June 29, 2022

Consideration of a change-in-use from a professional office to a residential facility that includes interior remodel, enclose courtyards, and updated exterior materials. The subject site is located at 524 Manzanita Street and is identified on the Jackson County Assessor's map as 37S 2W 02CC, Tax Lot 2200. **Applicant:** ColumbiaCare Services, Inc.; **Agent:** Rhine-Cross Group, LLC (Marc Cross).

**BURDEN OF PROOF APPLICATION
FOR
CCS – TENANT IMPROVEMENTS – 524 MANZANITA STREET
CENTRAL POINT, OREGON**

PRELIMINARY SITE PLAN
 TENANT IMPROVEMENTS
COLUMBIA CARE SERVICES INC.
 524 MANZANITA STREET
 CENTRAL POINT, OREGON
 MAY 2022

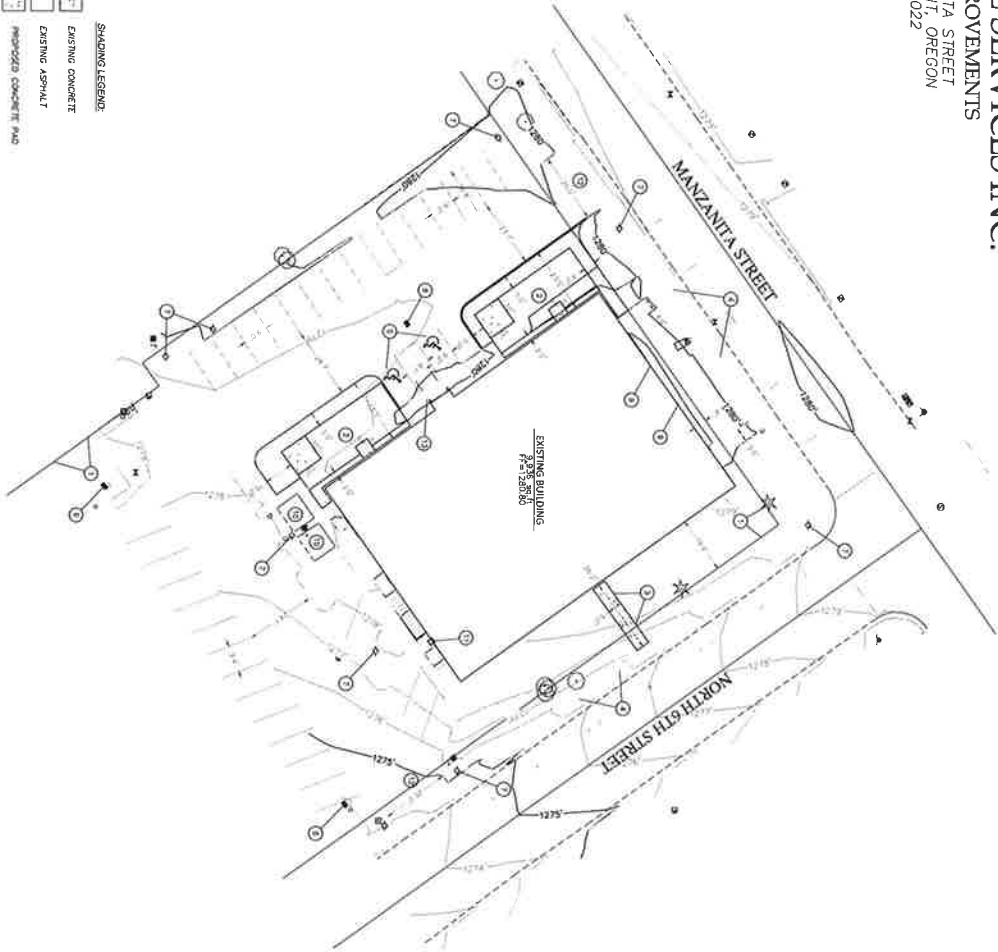
1. Landscape Plan – As part of the exterior improvements, the Applicant proposes to construct two (2) enclosed parking areas adjacent to the west side of the building. In accordance with CPMC 17.67.050(K), trees and shrubs shall be protected from damage by vehicles and fence materials must comply with acceptable screening types. Staff recommends Condition No. 1 requiring the applicant to submit a landscape plan depicting the location and type of landscape and fence materials prior to the issuance of building permits.

1. Submit a landscape plan that depicts the location and type of landscape materials and screening/fence type and height. Landscape materials must be protected from damage by vehicles and dispersed throughout the landscape area. Fence materials shall not consist of prohibited material types.
2. Coordinate with Fire District #3 and demonstrate compliance with the Staff comments, including any and all required safety features and building elements for the change of use from an office "B" type use to a residential "R" type use.
